ADDENDUM NO. 2

PROJECT NAME: **UNL East Stadium
Athletic Performance Lab**

UNL PROJECT NUMBER: C049P139

DATE OF ISSUANCE: November 30, 2012
DATE OF BID OPENING: **Thursday, December 6, 2012**

Attachment No. **A2**
to Addendum No. 2
Dated: 11-29-2012

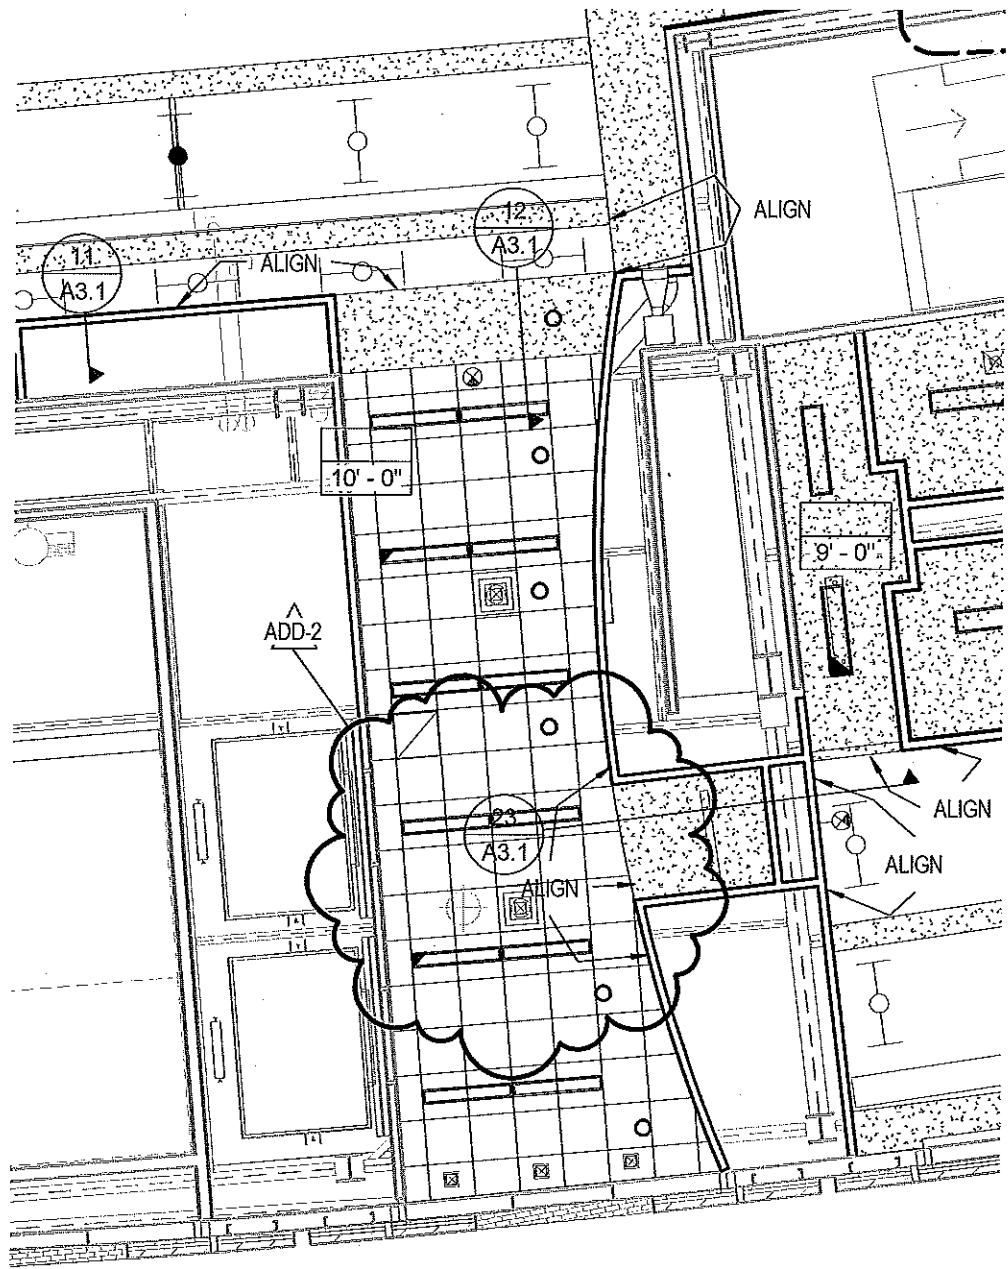
- A. 13/A2.1 – Modify drawing per Attachment A-1
- B. 33/A2.1 – Delete note, “...INTO REAR OF UPPER CABINET” and substitute, “COORDINATE FINAL LOCATION WITH OWNER”
- C. A2.1 – Modify “ABBREVIATIONS” per Attachment A-2
- E. 21/A2.1 – Delete note, “ACCESS PANEL” and substitute, “2’-0”X2’-0” ACCESS PANEL”

Attachment No. **A3**
 to Addendum No. 2
 Dated: 11-29-2012

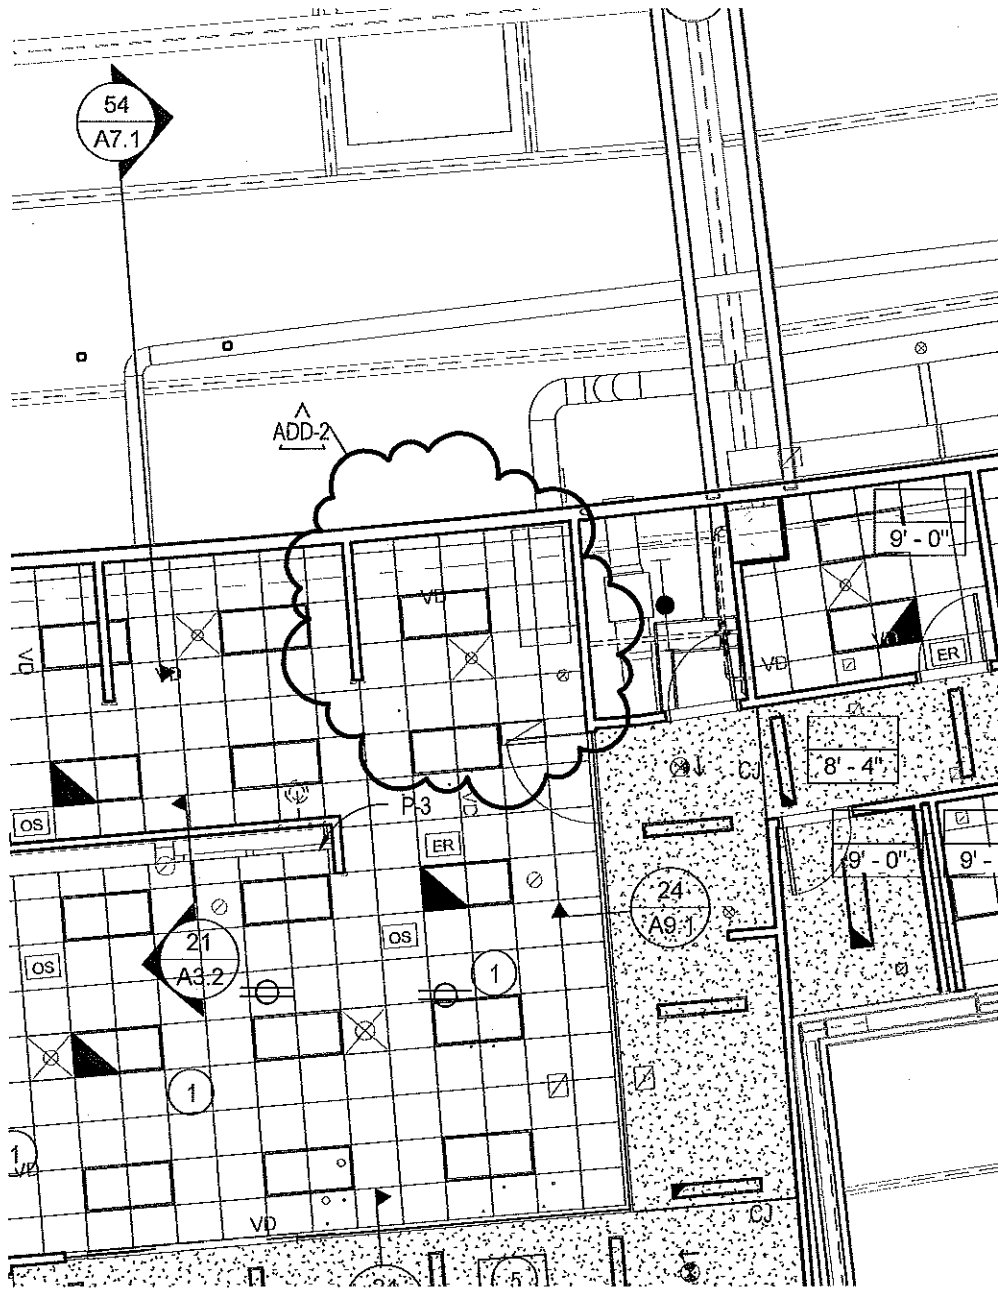
- A. A3.1 – REFLECTED CEILING PLAN – LOWER LEVEL – AREA C - Modify drawing per Attachment A-3
- B. A3.1 – REFLECTED CEILING PLAN – UPPER LEVEL – AREA C - Modify drawing per Attachment A-4

15 HC SHOWER CURB
 A10.1 SCALE: 1 1/2" = 1'-0"

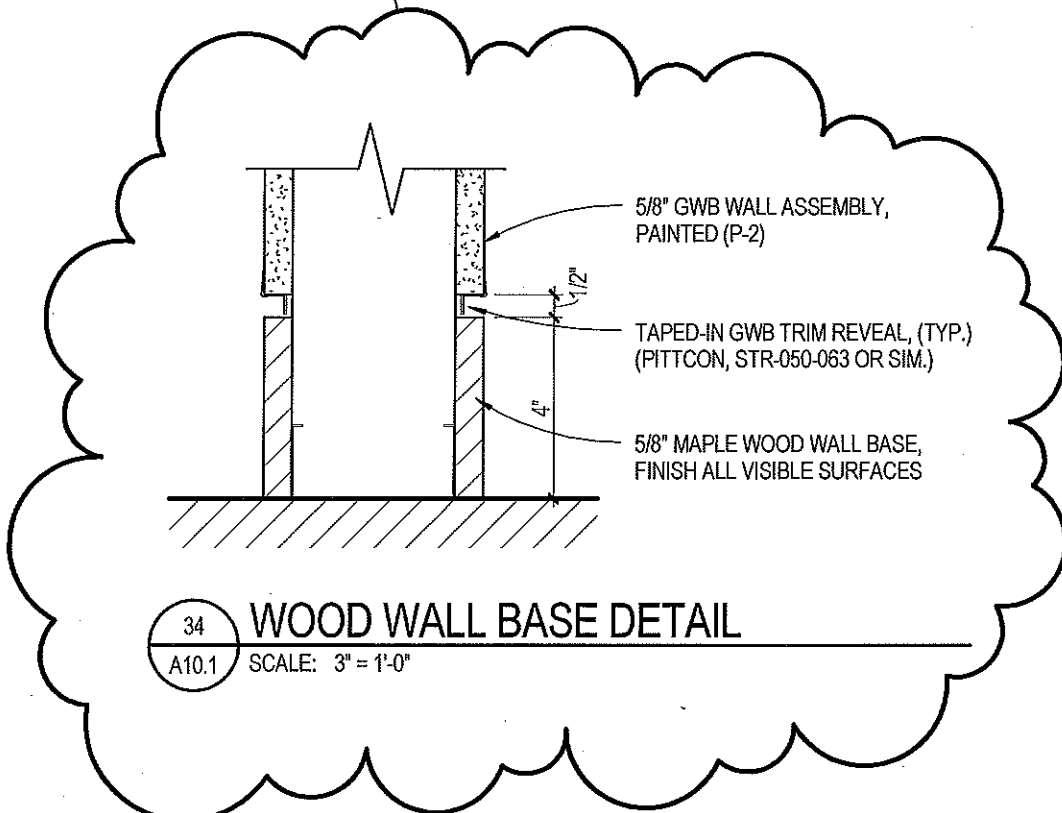
- A. 13/A10.1 – At sub-detail "A" Delete "12B" and substitute "13B"
- B. 15/A10.1 – Revise detail per Attachment A-5
- C. 34/A10.1 – Add detail per Attachment A-6

Attachment No. M1
to CC-2
Dated: 11-29-2012

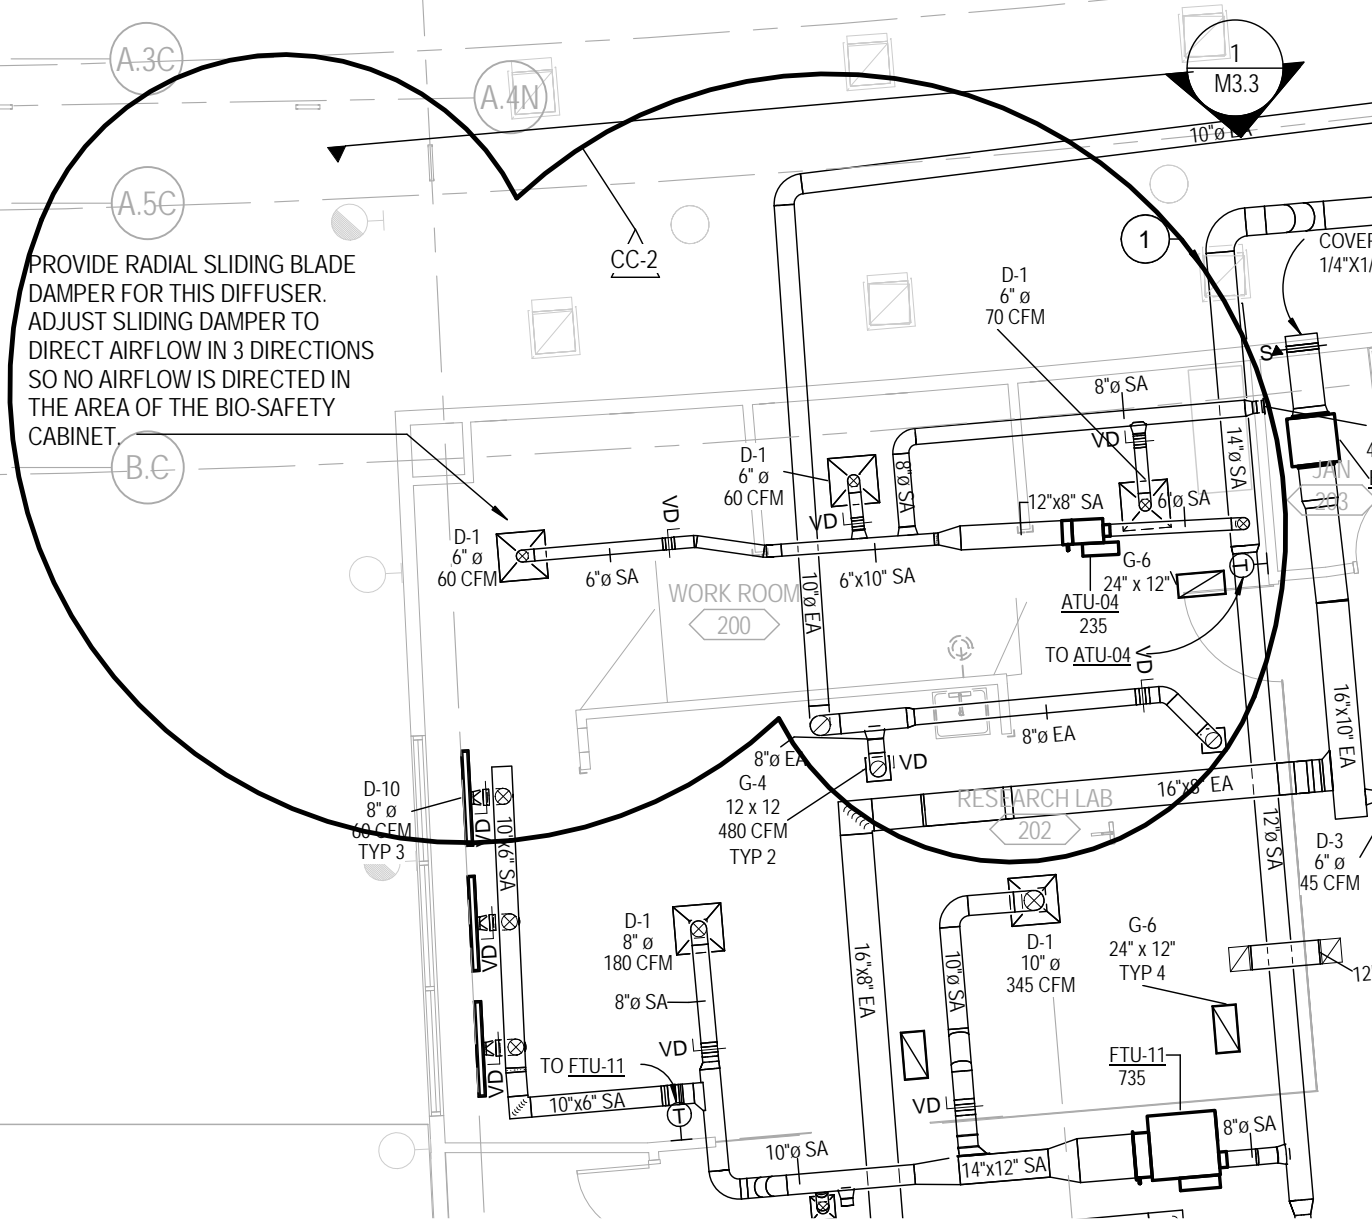
- A. ROOM 105: Delete volume dampers in return ducts at FTU-3 and FTU-4.
- C. Modify drawings as shown on Attachment M1 to Addendum No. CC-2 dated November 29, 2012.

PROVIDE RADIAL SLIDING BLADE DAMPER FOR THIS DIFFUSER.
 ADJUST SLIDING DAMPER TO DIRECT AIRFLOW IN 3 DIRECTIONS
 SO NO AIRFLOW IS DIRECTED IN THE AREA OF THE BIO-SAFETY
 CABINET.

Attachment No. M2
 to CC-2
 Dated: 11-29-2012

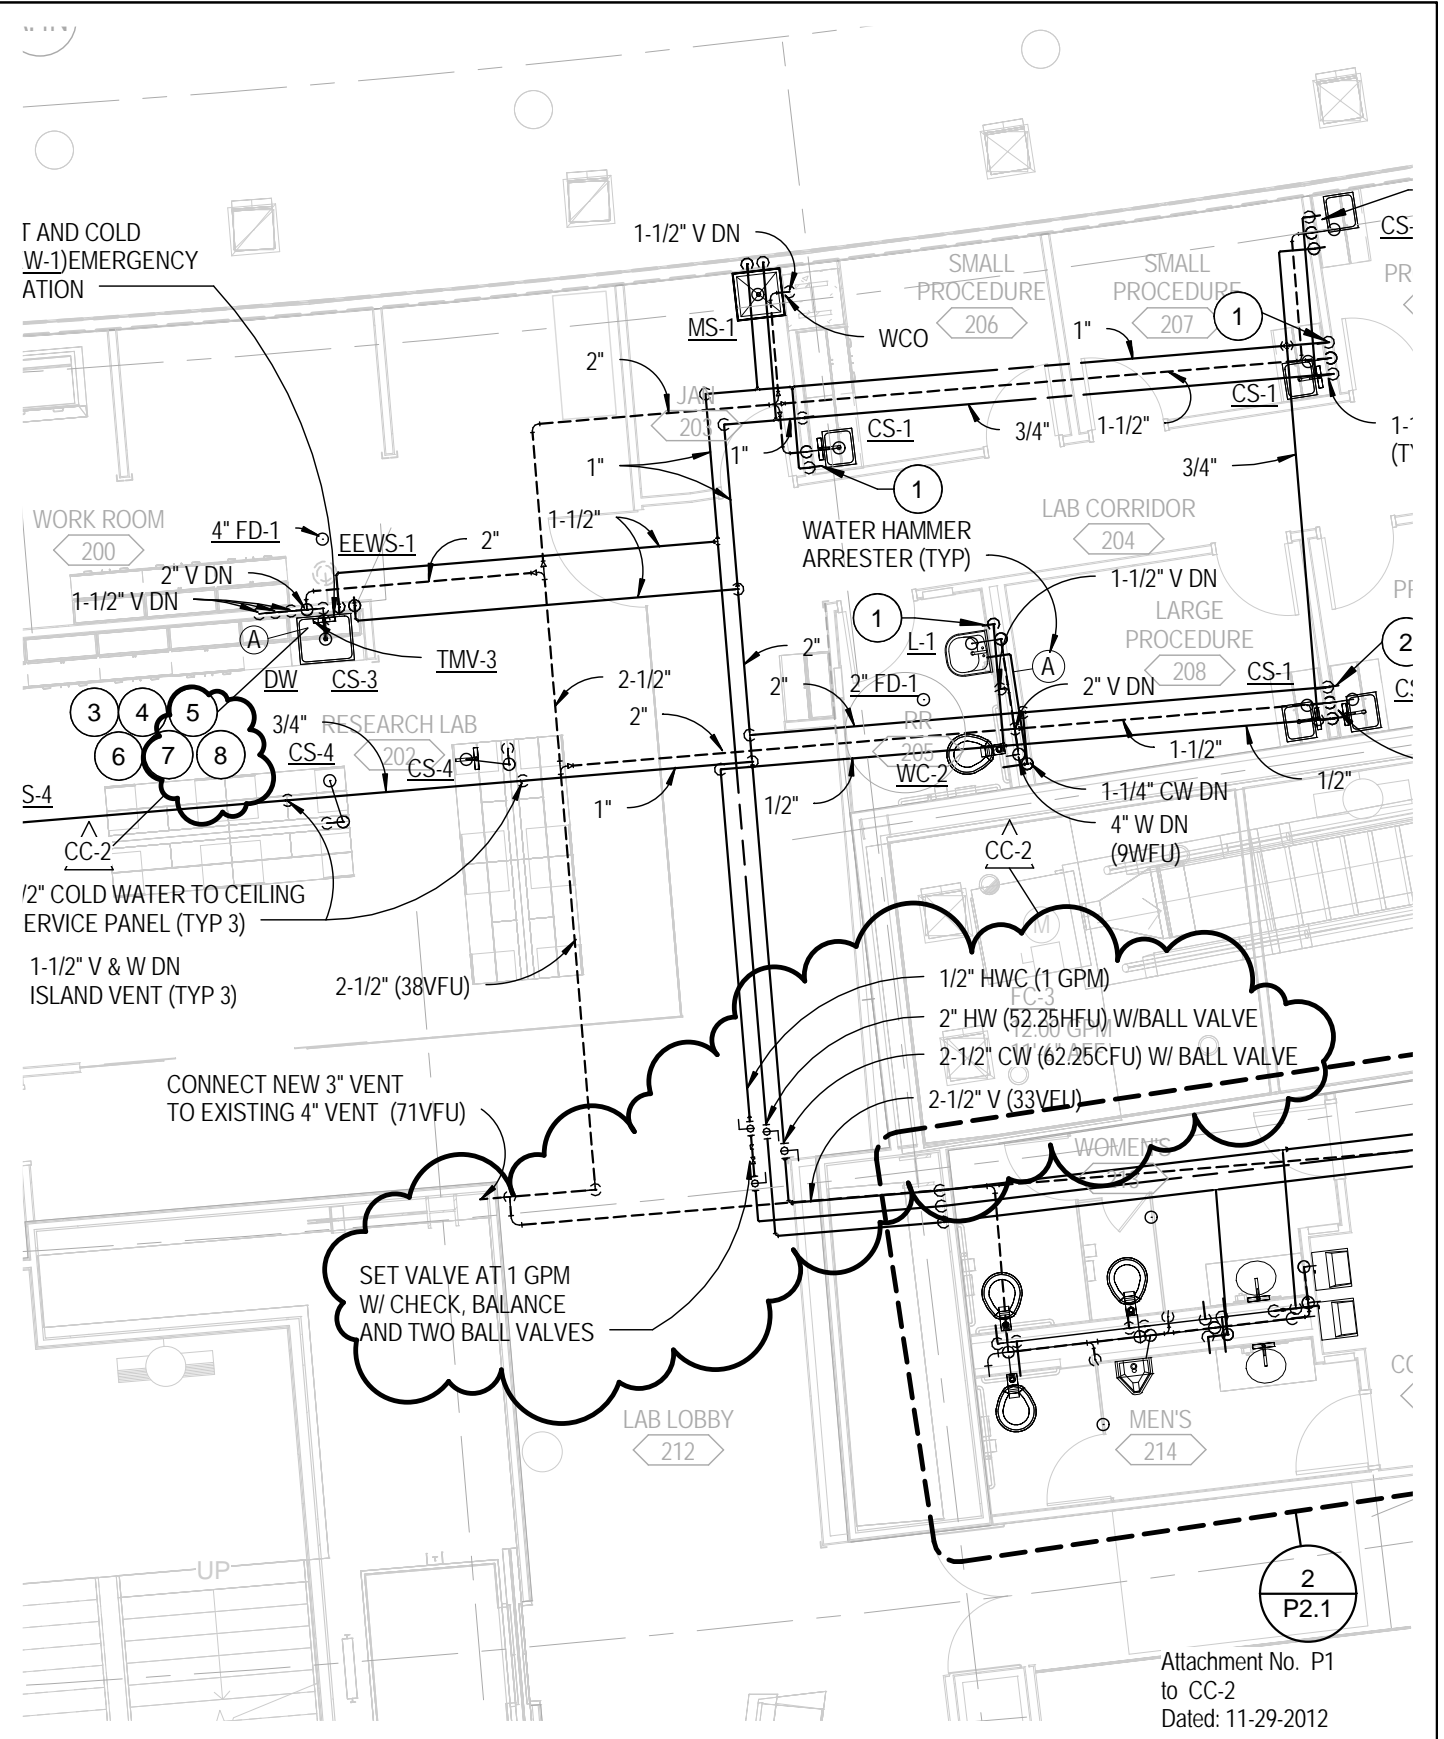
- A. Modify drawings as shown on Attachment M2 to Addendum No. CC-2 dated November 29, 2012.

Attachment No. P1
to CC-2
Dated: 11-29-2012

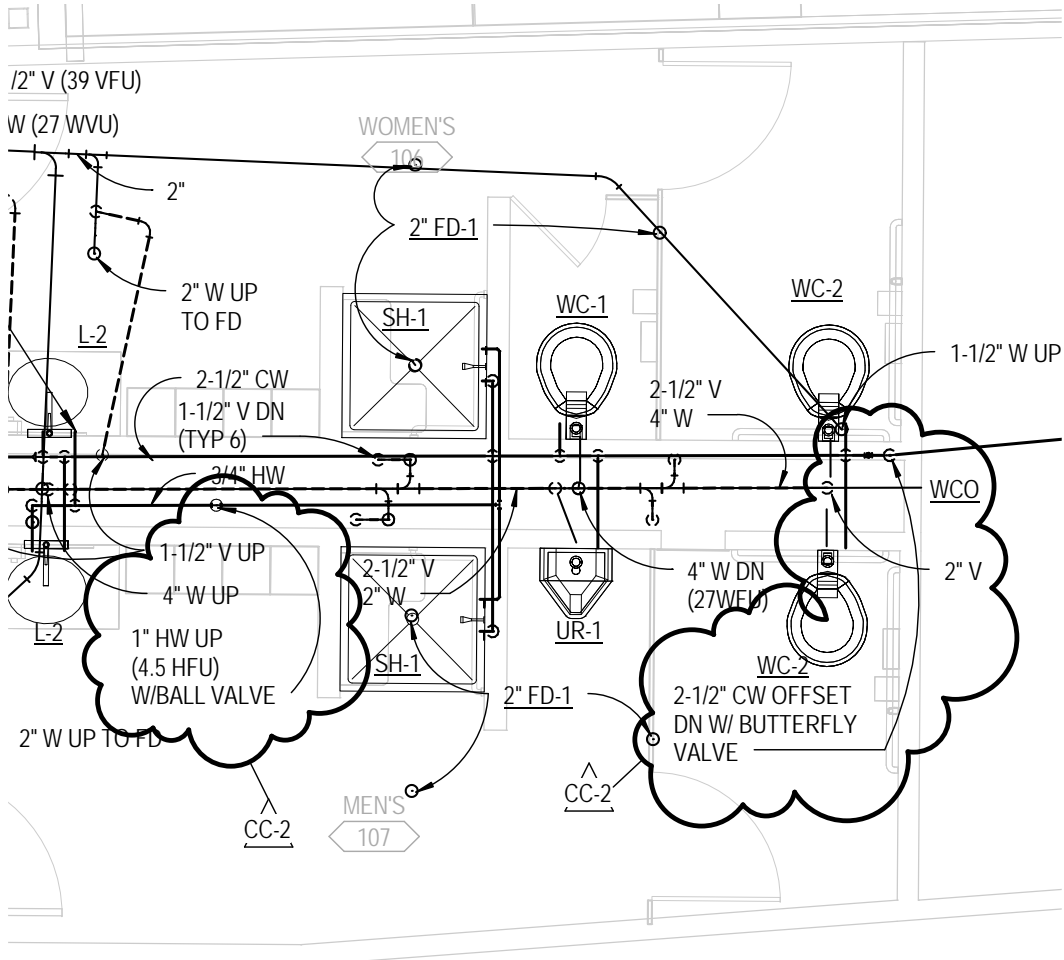
- B. Modify drawings as shown on Attachment P1 to Addendum No. CC-2 dated November 29, 2012.
- B. Modify drawings as shown on Attachment P2 to Addendum No. CC-2 dated November 29, 2012.
